March 10, 2014

RE: EPA Application Completeness Determination and Request for Information
Greenhouse Gas PSD Permit Application
M&G Resins USA, LLC
Polyethylene Terephthalate and Terephthalic Acid Units
Corpus Christi, Nueces County, Texas

ATTACHMENT A

EasyUp™ – An Innovative Approach

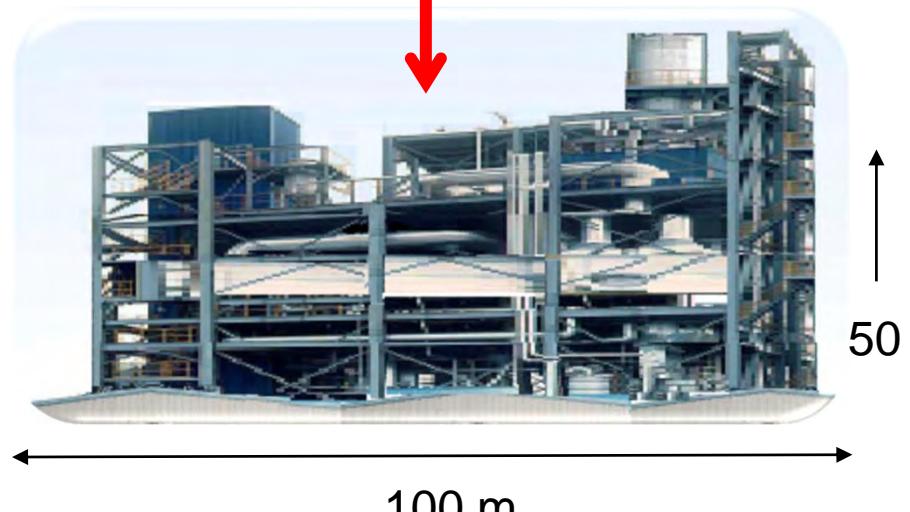
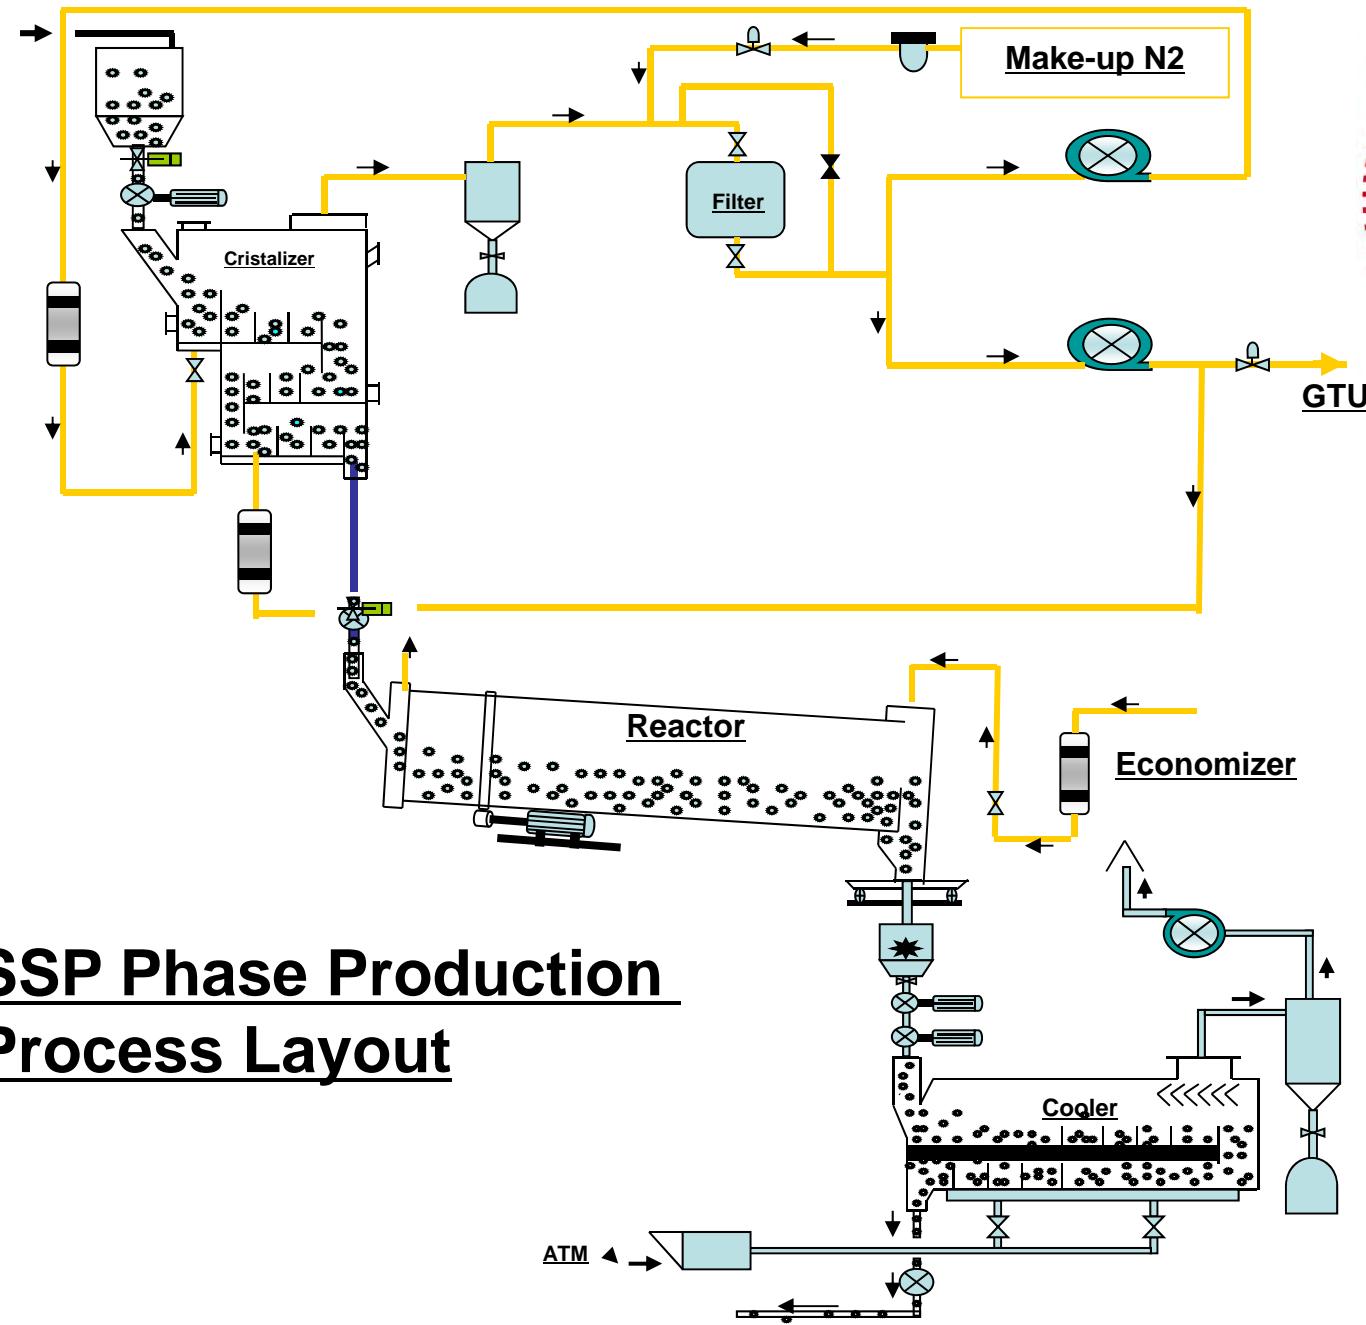
ZEC Counter	I-Letter No.	Instruction	Response
61	3	Provide supplemental information that compares the efficiency gains in heat and electricity consumption or reduction in GHG emissions for chosen technology versus traditional PET technology.	A comparison of technologies and their energy consumption is provided in Attachment B.
62	3	Provide a copy of any technical resources used to evaluate the design decisions for the M&G facility and any benchmark comparison data of similar sources existing nationally or internationally, that may have been utilized in the design selection strategy.	A comparison of technologies and their energy consumption is provided in Attachment B.
63	3	Please provide technical resources, literature and calculations to substantiate the claimed efficiencies.	A comparison of technologies and their energy consumption is provided in Attachment B.
64	4	Please provide supplemental information that quantifies the amount of potential GHG emissions that will be minimized and reduces the amount of imported natural gas by using the biogas generated from the WWTP as fuel to the process heaters.	A comparison of technologies and their energy consumption is provided in Attachment B.

- The streamlined process for M&G EasyUp™ requires less equipment than utilized in traditional technology
- M&G EasyUp™ technology avoids the impact of a vertical tower and has no capacity limitation for a single line

CP – SSP Integration

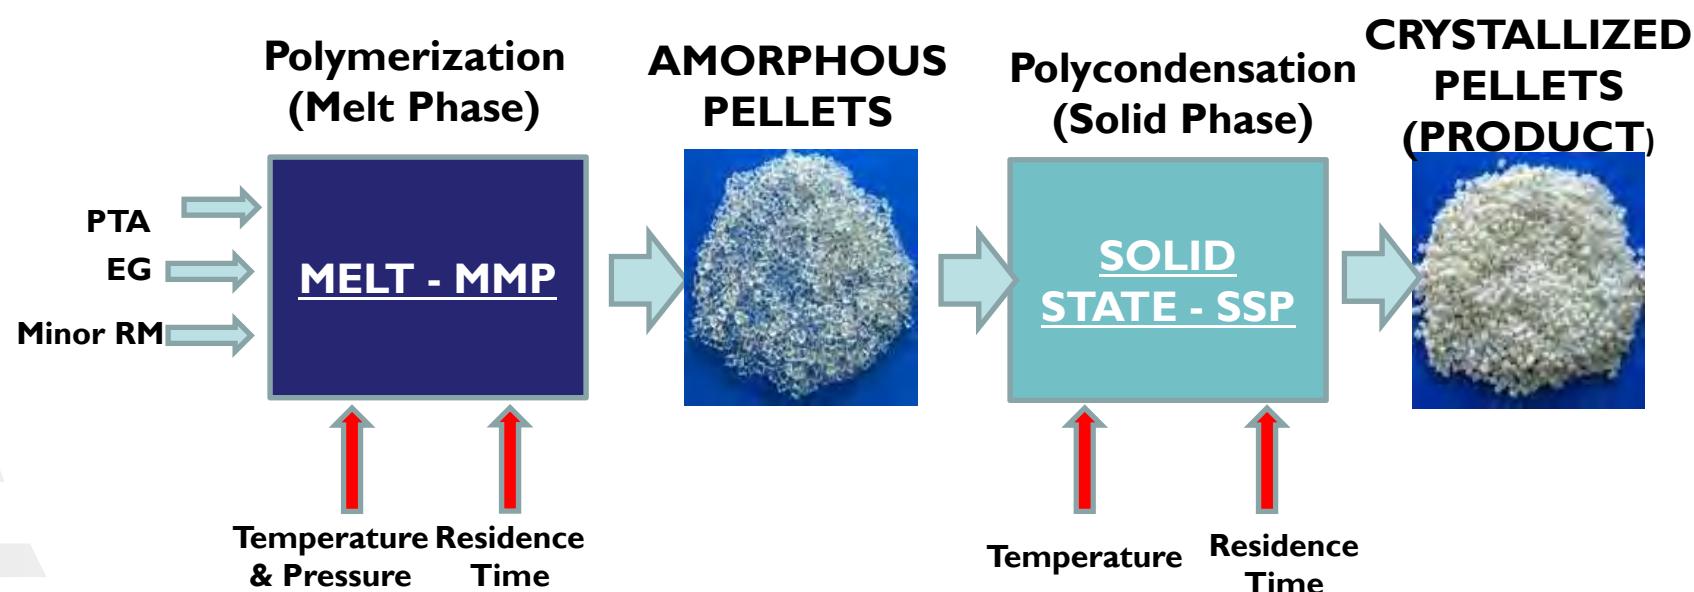
Response to following questions from the EPA completeness letter and associated data request letter dated February 5, 2014.

- Optimize designs of CP, Chip making, & SSP to maximize:
 - Operational flexibility
 - Best product performance
 - Attractive CAPEX for the whole plant
 - Compact layout
 - Ease of operation
- Flexible commercial options
